PIC18F06/16Q41 Silicon Errata and Data Sheet Clarifications

PIC18F06/16Q41

Introduction

1.5.1 UART TXDE Signal May Go Low Before the STOP Bit Has Been Entirely Transmitted

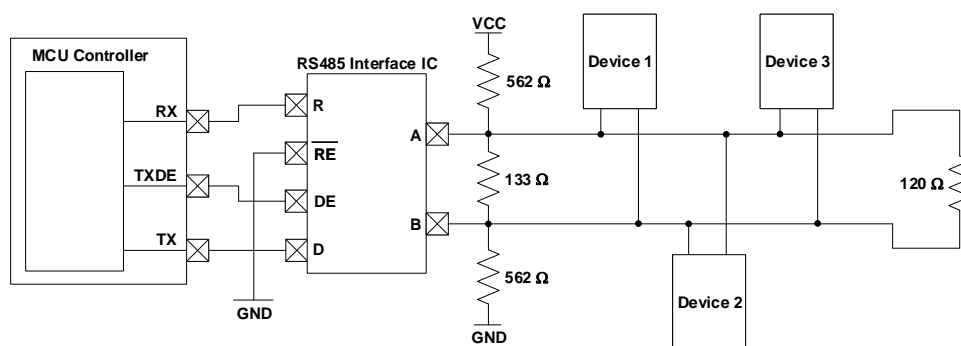
The UART Transmit Drive Enable (TXDE) signal could potentially transition into a low state before the UART STOP bit has been entirely transmitted due to the effects of parasitic capacitance on the TX line. In some applications, this could result in communication being prematurely terminated due to the TXDE signal going low before the STOP bit has had enough time to settle.

To ensure that the STOP bit settles into its final logic state before the TXDE signal transitions low, a biasing circuit can be implemented. A biasing circuit allows the TX line to either be driven high or low, rather than being left in a floating tri-state mode where prolonged rise or fall times could lead to communication being disrupted. This bias circuit should only be implemented on one end of the serial bus, and a termination resistor should be used on the other end. The figure below shows an example of a bias circuit that can be used to achieve this.

Please note that the resistor values used in this circuit are recommendations and that the actual resistor values required may vary based on the application.
